Rezoning Transportation Analysis

Petition Number: 2019-173

Date	Description
01-17-2020	First Review
05-20-2020	Second Review (WB)

SECTION A - A
PROPOSED ROAD IMPROVEMENTS
(FUTURE BY OTHERS)

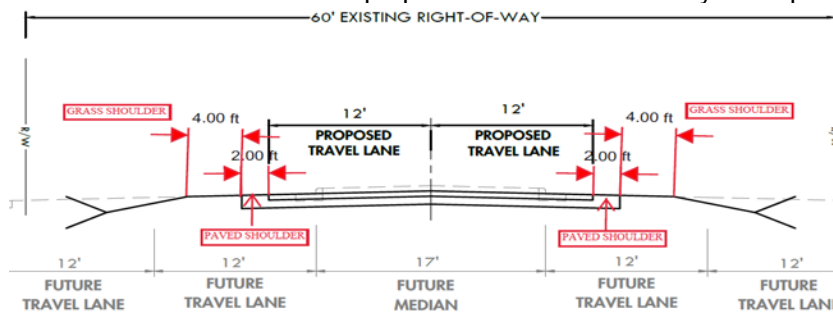
6. **New Comment based on revised site plan 05-11-2020:** The petitioner should revise the site plan and conditional notes to commit to construct 2-12' lanes with 2' paved shoulders and 4' grass shoulders. for Section A-A. The petitioner should add a note stating the final details will be determined during permit review process to include input from other departments including but not limited to CDOT, General Services, Charlotte Fire Department, the NCDOT. Also include that any applicable ordinance requirements in addition to what is shown on proposed cross-sections may be required

SECTION B - B
PROPOSED ROAD IMPROVEMENTS
(FUTURE BY OTHERS)

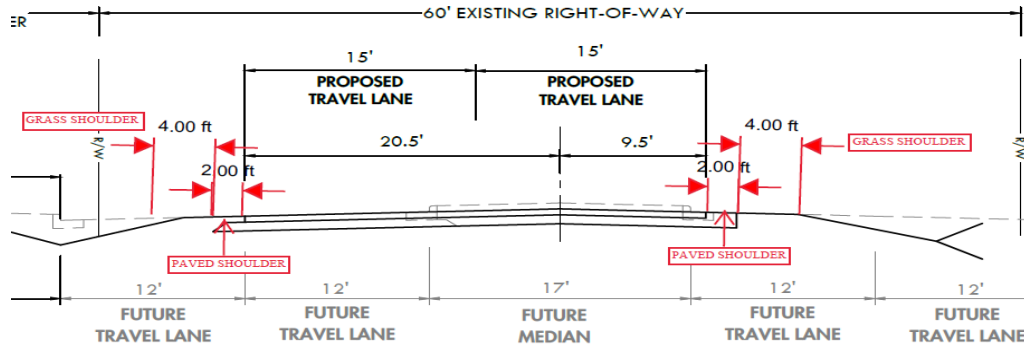
- New Comment based on revised site plan 05-11-2020:** The petitioner should revise the site plan and conditional notes to commit to construct 2-12' lanes with 2' paved shoulders and 4' grass shoulders for Section B-B. The petitioner should add a note stating the final details will be determined during permit review process to include input from other departments including but not limited to CDOT, General Services, Charlotte Fire Department, the NCDOT. Also include that any applicable ordinance requirements in addition to what is shown on proposed cross-sections may be required

SECTION C - C
PROPOSED ROAD IMPROVEMENTS
(FUTURE BY OTHERS)

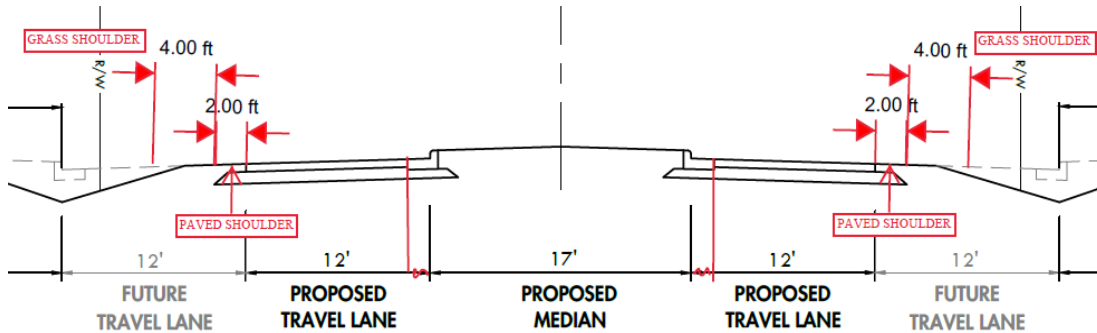
- New Comment based on revised site plan 05-11-2020:** Cross-section C-C depict the general intent of a 3-lane section (2 travel lanes and center turn lane and/or planted median) and a shared-use path for an interim version of future Garrison Road. The petitioner should revise the site plan and conditional notes to commit to construct 2' paved shoulders and 4' grass shoulders. The petitioner should add a note stating the final details will be determined during permit review process to include input from other departments including but not limited to CDOT, General Services, Charlotte Fire Department, the NCDOT. Also include that any applicable ordinance requirements in addition to what is shown on proposed cross-sections may be required.
